National Highways Planning Response (NHPR 25-01) Formal Recommendation to an Application for Planning Permission

Council's Reference: DM/25/2661

Location: Land at Coombe Farm, London Road, Sayers Common

National Highways Ref: NH/25/13461

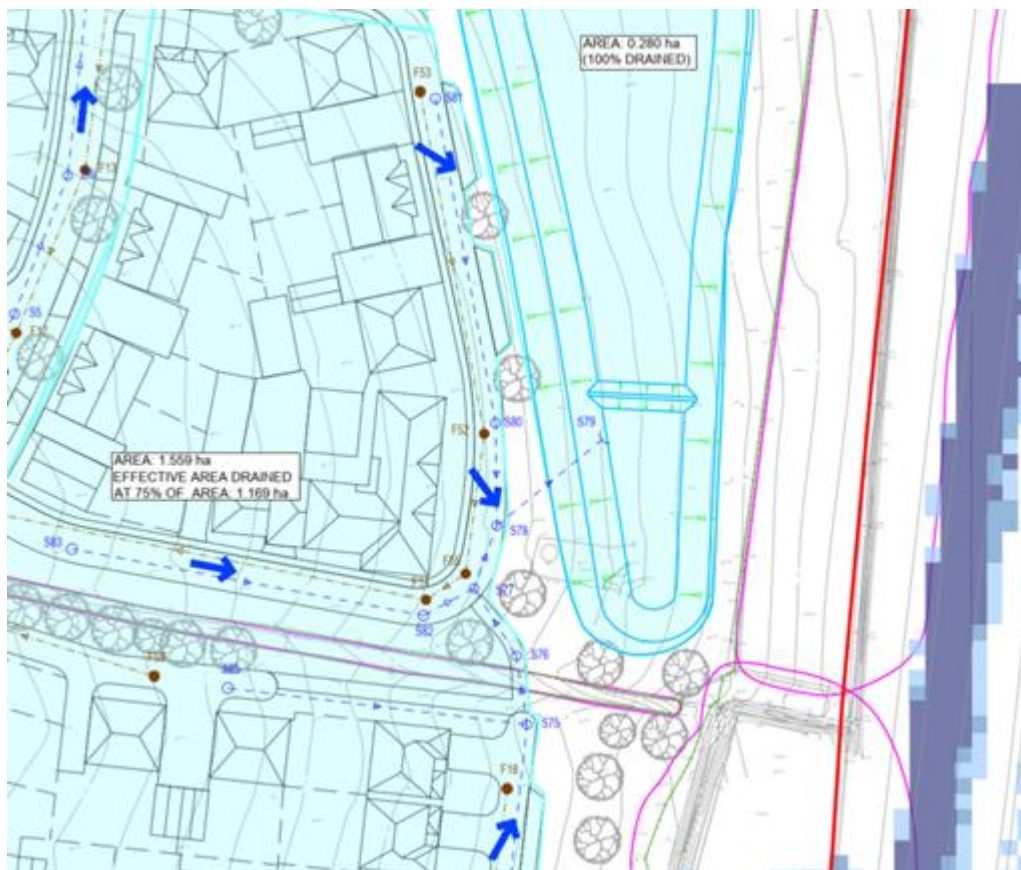
The drainage layout demonstrates that most of the site's topography falls away from the A23 however **a section of land along the eastern boundary falls towards the A23. We will therefore require cross-sections of this area to better understand the proposed development overland flow and how it does not enter the SRN drainage system. The cross-sections should cover the development's low point and include the proposed basins, SRN drainage ditches, SRN boundary. See the image below for the general area of concern.**
